RS-20-069

Clinton Power Station, Unit 1  
Facility Operating License No. NPF-62  
NRC Docket No. 50-461

Subject: Additional Information Supporting Request for License Amendment Regarding Automatic Operation of Transformer Load Tap Changer

**ATTACHMENT**  
**Response to Request for Additional Information**

**Left and Right Sides of ERAT Control Panel**

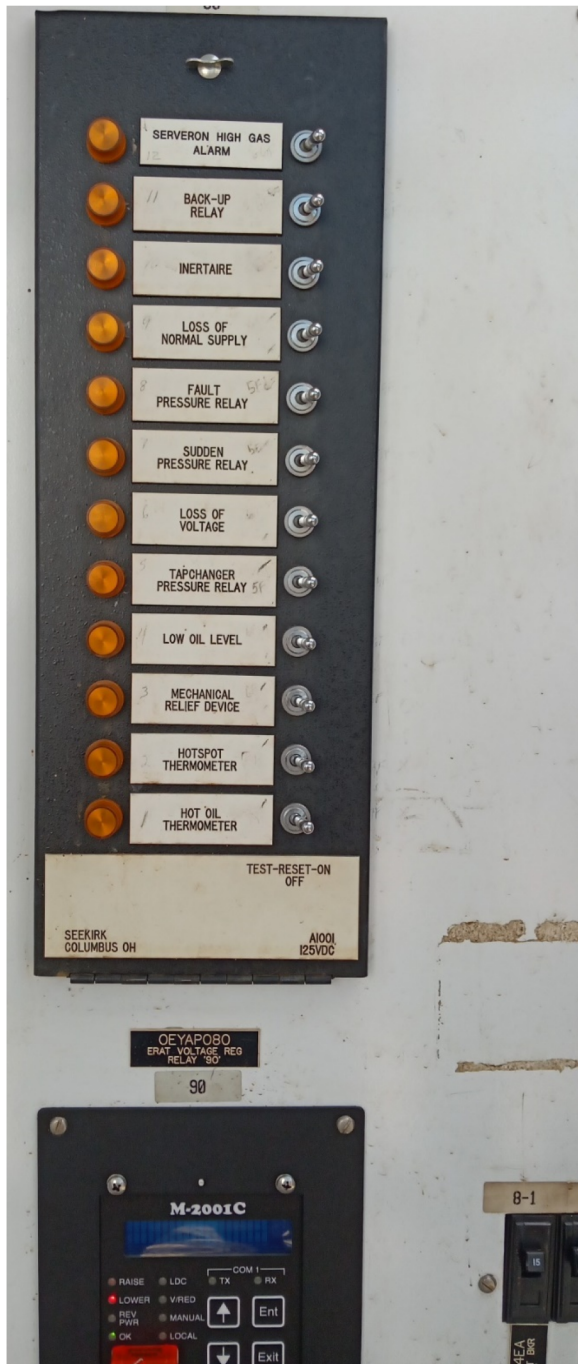
- (a) Provide a frontal diagram of the LTC control panel showing location and name tag of each device.
- (b) Provide the available range and actual setpoints for the VRR Bandcenter and Bandwidth to provide adequate voltage at the Class 1E 4.16 kV ESF buses (within certain design limits) for satisfactory functioning of ESF equipment.

Photos showing the location and name tag of the LTC equipment are provided below.

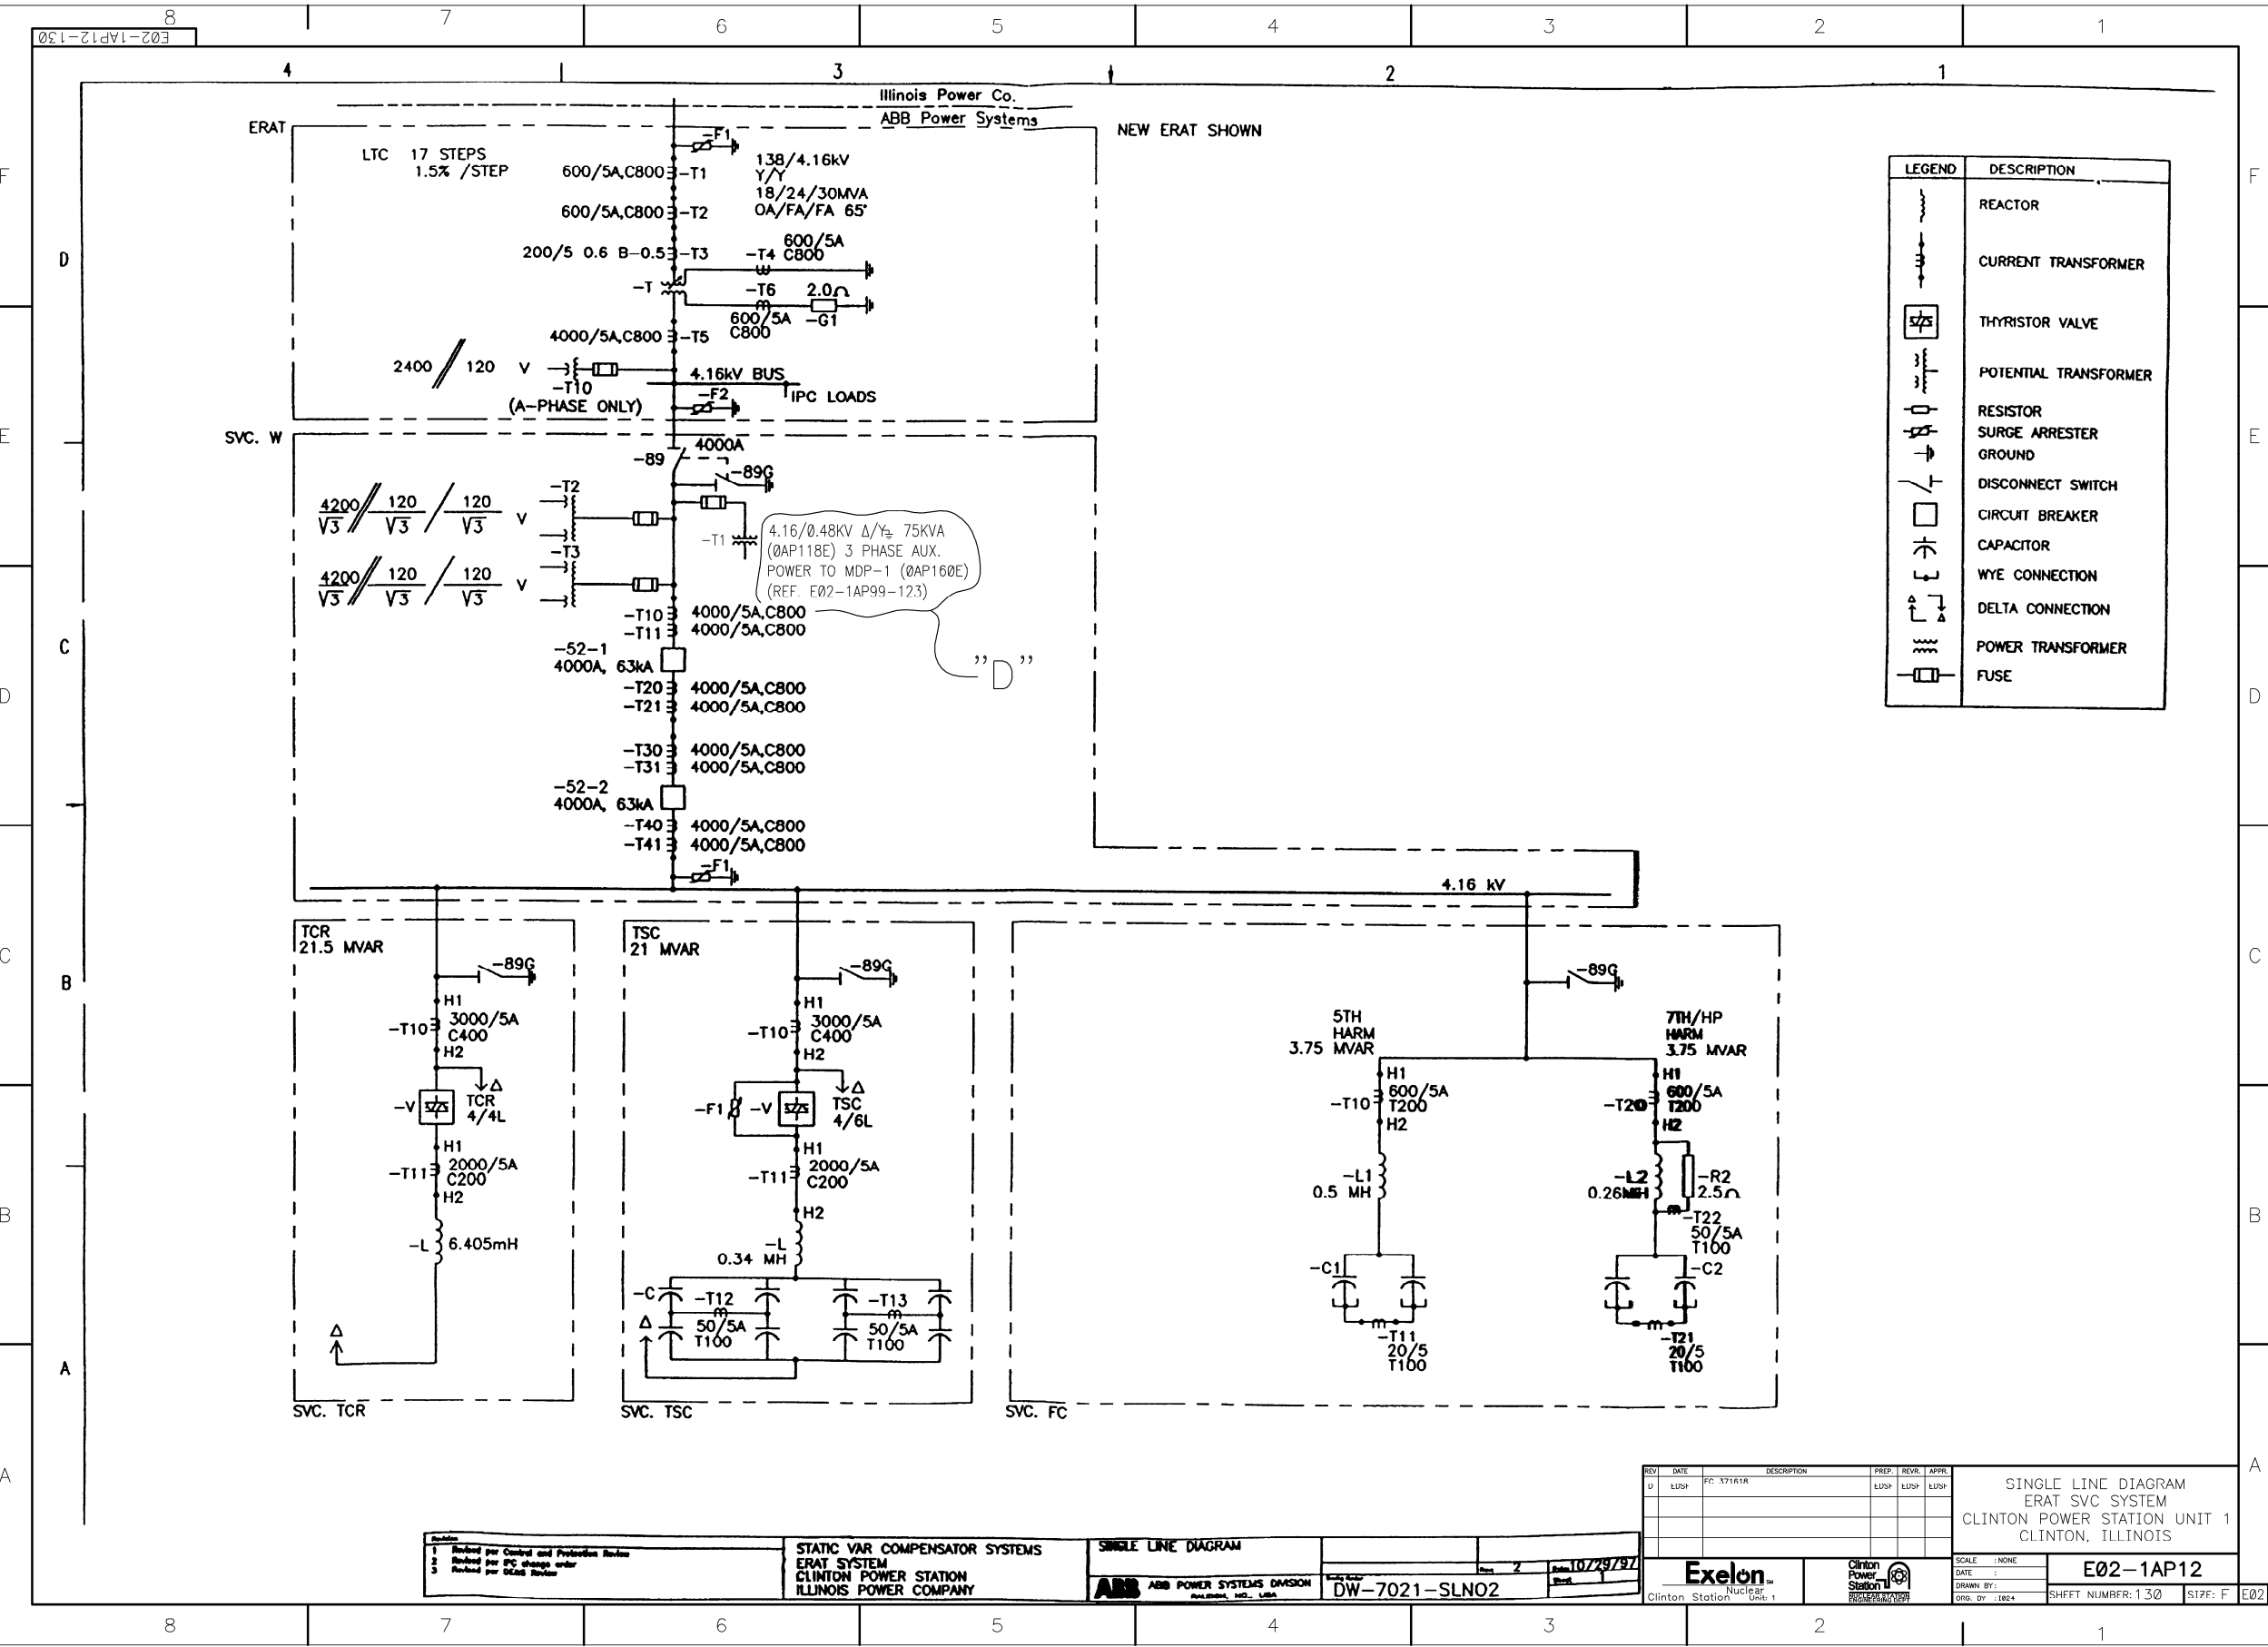
The location/connection of SVC is not shown in any drawings currently available in the USAR, Chapter 8. Provide a copy of Drawing E02-1AP03 referenced in USAR, Chapter 8, or any other drawing which shows location/connection of SVC.

Drawing E02-1AP12, Sheet 130, "Single Line Diagram ERAT SVC System," and drawing E02-1AP12, Sheet 133, "Single Line ERAT SVC Interconnections," are provided at the end of this Attachment. These drawings show the location/connection of the SVC.
